**Goldfields Gas Pipeline  
Access Arrangement 2015 – 2019**

**Comments  
on  
Pipeline Capacity Modeling  
and  
the Impact of Changing Gas Quality**

**Draft: 29 May 2016**

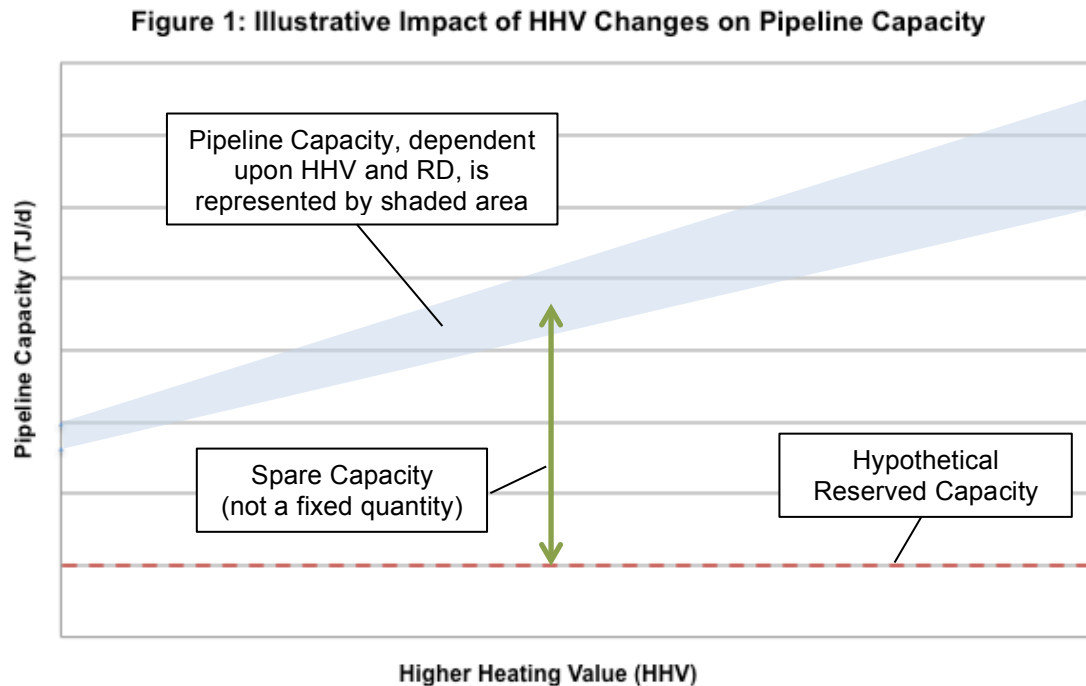
4.1 As set out in Section 4 of this Report changes in the composition of a gas, and hence its HHV, will have an impact upon the ultimate capacity of the pipeline through which the gas is transported. This relationship is illustrated in Figure 1.

4.2 I agree that transportation of gas with a HHV lower than the level previously adopted for planning purposes will reduce the capacity of the GGP (in TJ/d terms).

4.3 Based upon my knowledge and experience I consider the following may be worthy of future consideration:

- i) the capacity of the GGP could be determined on the basis of a clearly specified gas quality, potentially reflecting the average quality of gas it is anticipated will be transported through the GGP; and
- ii) a mechanism could be formulated whereby each user's capacity reservation(s) and applicable tariffs are adjusted to reflect the quality of gas actually transported on their behalf. This approach would ensure users pay for volumetric capacity that must be used to transport their gas.

Figure A1.2: Gas Quality Measures for Mixes of C1, C2, CO<sub>2</sub> and N<sub>2</sub>

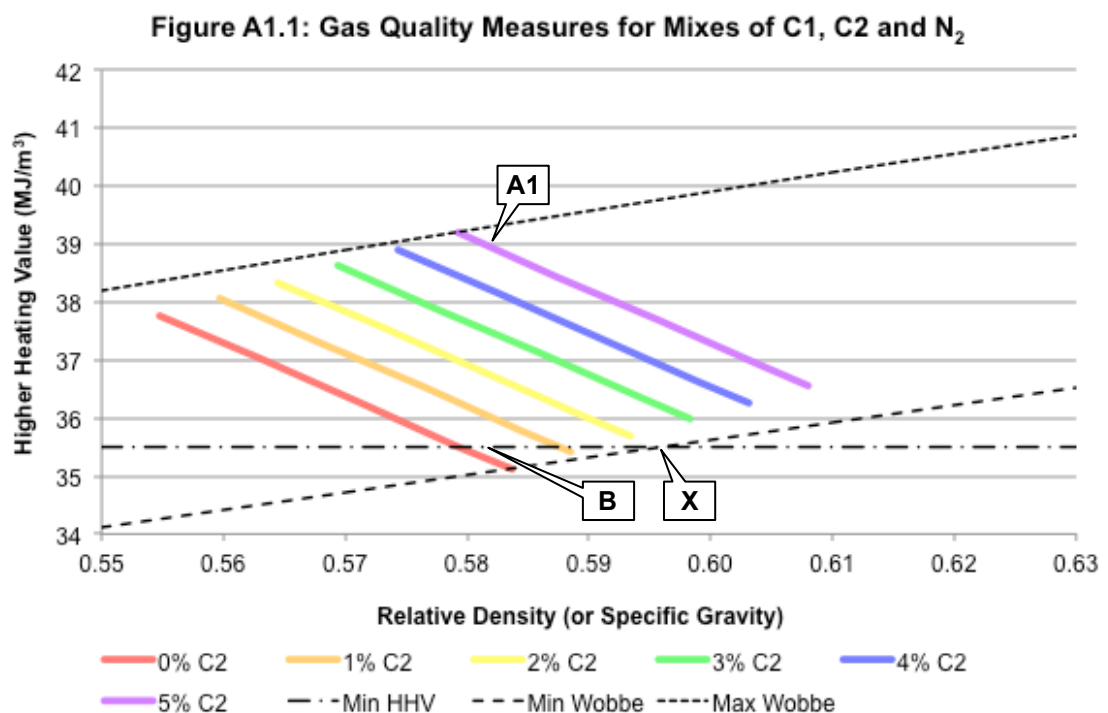
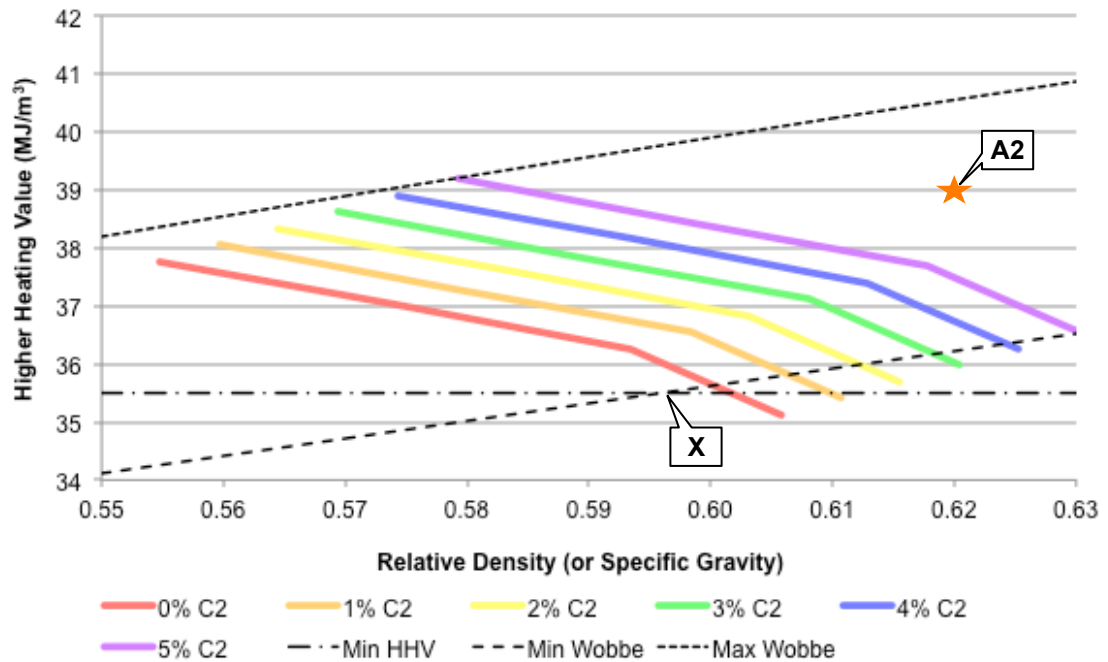
- 3.4.2 Attachment One also shows that a gas with a HHV as low as 35.5 MJ/m<sup>3</sup> will necessarily have a Relative Density less than 0.596, otherwise the legislated minimum Wobbe Index requirement (46.0 MJ/m<sup>3</sup>) will be breached.

- i) For a gas to have a HHV of 35.5 MJ/m<sup>3</sup> without breaching the minimum Wobbe Index requirement, that gas will need to comprise predominantly methane and nitrogen, with only modest amounts of higher hydrocarbons (C2 and higher) and/or carbon dioxide. Addition of higher hydrocarbons or carbon dioxide will result in the constraining gas quality criterion being minimum Wobbe Index, not minimum HHV.
- ii) Following on from point 1) above, a gas with a HHV of 35.5 MJ/m<sup>3</sup> will have a Relative Density less than 0.596, corresponding with compositions to the left of the point marked 'X' in Figures A1.1 and A1.2.
- iii) Gas with a HHV of 39.0 MJ/m<sup>3</sup> will necessarily have a Relative Density higher than approximately 0.575.
